**SAFETY NOTICE**

**SN 627**

**Models Affected:** SCM48, SCM50, & SCM55

**SUBJECT:** *SCM LEVELING SYSTEM*

PART NAME: STOP BLOCK  
PRODUCT: Z1383  
MATERIAL: ASTM A572 GR50 HR  
DRAWN BY: MJH DATE: 11/20/2015  
ASSY: 9157514  
MASS: 2.45 LBS  
STOCK SIZE: 1.00 x 2.00  
NOT TO SCALE  
FORM# 3469B

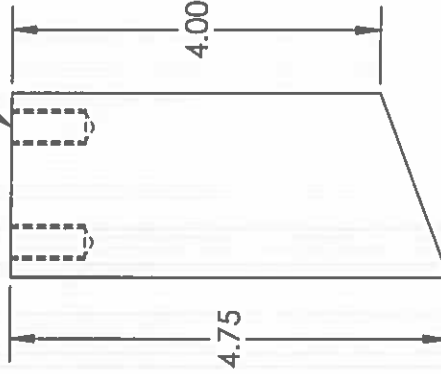
Terex has become aware of an issue where the leveling cylinder, at the elbow, and elbow sprocket leveling arm on SCM units built from August 24, 2011 to November 5th, 2015 can be forced past their aligned position (i.e. cam over). If continued to operate in this condition the leveling system can fail. **If the leveling system fails the platform can tilt unexpectedly which can result in the platform occupants falling.**

Terex will install a stop to prevent the cylinder from being forced past center. The repair will be provided at no cost to the owner. For further assistance call TEREX Utilities at 1-800-982-8975 and ask for the Service Department.
